PLANNING NMA-CHANGE LIST		
ID	Proposed Changes to plans that are 'Non Material'	Reason for 'Amendment'
A	Changes to Common stair towards compliance for general access where a clear landing needs to be provided and to accommodate smoke control. Circulation area and internal doorway to stairs rearranged to adapt corridor aisle. Stairs, structurally stacked for construction leading towards the corridor or lobby next to the stair being provided with a smoke vent and a store area provision on ground level. Rearrangement in plan due to the above visible on the Northeast facade. Window openings, adapted to suit mentioned changes/rearrangement.	Compliance towards Building Regulations, Part-K-Protection from falling, collision and impact and Part-B-Fire safety
B	Changes to Communal lifts and stairs towards compliance for firefighting where a firefighting shaft is required as the building is over 18m and to accommodate smoke control and building services. Circulation area internal doorway to stairs and clear landing for lifts rearranged to adapt corridor aisle. Stairs, structurally stacked for construction leading towards a vertical smoke shaft that opens at roof level with rationalised comm

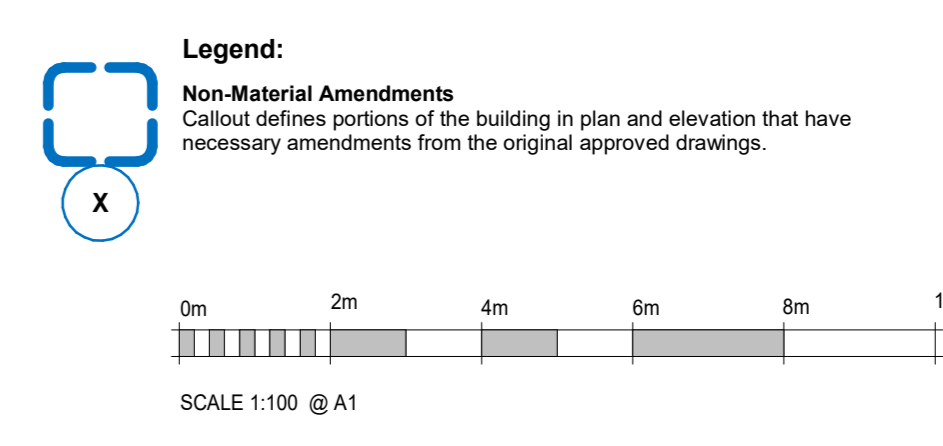
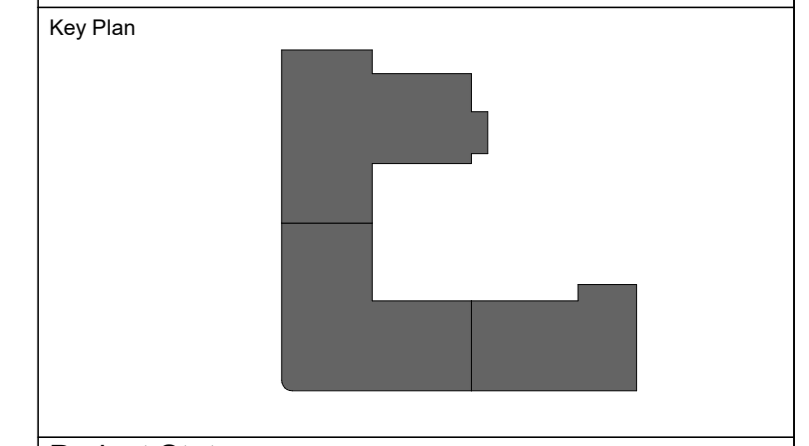
C	Changes to communal roof gardens (landscaping) including change of barrier type (railing) from glazed balustrade to counterbalance metal railing.	To contribute positively towards biodiversity via balance of soft and hard landscaping schemes including provisions for bird and bat boxes, whilst maintaining overall uniformity for railing type.
D	Removal of photovoltaic (PV) cells on the roof	PV was not required as Part L requirement was met using Exhaust Air Heat Pumps.
E	Relocation of Substation and provision for Generator in allocated space.	Provision for separate secluded area for generator
F	Changes to provide new location for UKPN Substation	Provision for future relocation for UKPN Substation
G	Changes to ground level Cycle store to accommodate building services plant rooms including removal of two openings with rearrangement of the remainder openings.	Provision towards Building Services, Secondary LV switch room and Comms room.

H	Changes to ground level Cycle store to accommodate building services plant rooms including removal of two openings with rearrangement of the remainder openings.	Provision towards secure access and splitting into 4 small bin stores to comply with recent updates of having maximum 8 large (1100lrs) receptacles within.
J	Removal of Cycle store area and Bin store area at ground level, including external door in cycle store area towards provision to accommodate building services plant room including clear vehicular access towards undercroft parking.	Provision towards Building Services, Primary LV switch room and vehicular access towards undercroft parking.
K	Changes to ground level facade including removal of two openings to accommodate communal letter boxes with rearrangement of the remainder openings with provision for accessibility.	Provision towards communal letter boxes
L	Removal of undercroft parking entrance/exit at ground level towards provision for Relocation/Retention of existing UKPN Substation, whilst adding double doors as per change ID C-05.	Provision towards single point of entry/exit for undercroft parking and towards relocation/retention of existing UKPN Substation mentioned in change ID-E.

M	Changes to ground and first floor level, Common stair for means of fire escape and to accommodate smoke control to circulation area. Circulation area and internal doorway to stairs rearranged to adapt corridor aisle. Stairs, moved away from corridor aisle leading towards provision for an external smoke vent at first floor level. Rearrangement in plan due to the above visible on the Northeast facade. Ground level escape door, adapted to suit mentioned changes/rearrangement.	Compliance towards Building Regulations, Part-B-Fire safety.
N	Changes to ground level Cycle room and adjacent Store to replace provision for Cycle store area as per change ID C-09 via consolidation. Rearrangement in plan due to the above visible on elevations.	Provision towards replacement of removed cycle store mentioned in change ID-J.
P	Changes to Communal lift and stairs towards compliance for general access where a clear landing needs to be provided and to accommodate smoke control and building services. Circulation area internal doorway to stairs and clear landing for lifts rearranged to adapt corridor aisle. Stairs, structurally stacked for construction leading towards covered and enclosed stair at roof fourth floor level with rationalised communal entrance/exit. Rearrangement in plan due to the above visible on elevations.	Compliance towards Building Regulations, Part-K-Protection from falling, collision and impact, Part-B-Fire safety and Provision for stair enclosed/walkway that is directly covered.

Q	Changes to ground level Bin store arrangement to replace Bin store as per change ID C-09 via consolidation and enlargement to provide building services plant room. Rearrangement in plan due to the above visible on elevations.	Provision towards replacement of removed Bin store mentioned in change ID-J and provision for BCW Tank room
R	Changes to ground level openings, facade screens from circular pattern metal screens/vents to vertical extruded aluminium flats metal screen that match the railing type, including removal of one opening that clashes structural column on the corner way elevation.	To maintaining overall architectural uniformity and structural framing.
S	Removal of Green Wall as they do not comply with fire safety regulation 7(2).	Regulation 7(2), requires all residential blocks with top-storey heights over 18m to have all materials which become part of an external wall or specified attachment (e.g., balconies) to achieve class A2-s1, d0 or class A1, except for materials which are exempt as per regulation 7(3). Additionally, membranes used as part of external wall construction above ground should achieve a minimum of class B-s3, d0.

T	Changes to storage area, rearrangement towards desired storage required.	Provision towards desired storage required.
U	Discrepancy error on Comet way elevation whereby two window openings depicted would not have been located on the fifth-floor level plan as these would intrude privacy for the bathrooms.	Discrepancy error
V	Removal of single window, recessed brick reveals on the Northeast elevation.	The recessed brick reveals is towards the left of a single pane window for levels 1-4, whilst it changes to a double pane for level 5. To maintain architectural uniformity, we have detailed a constant double pane window for all levels.
X	Private path on western site boundary	For Façade maintenance MEWP access.
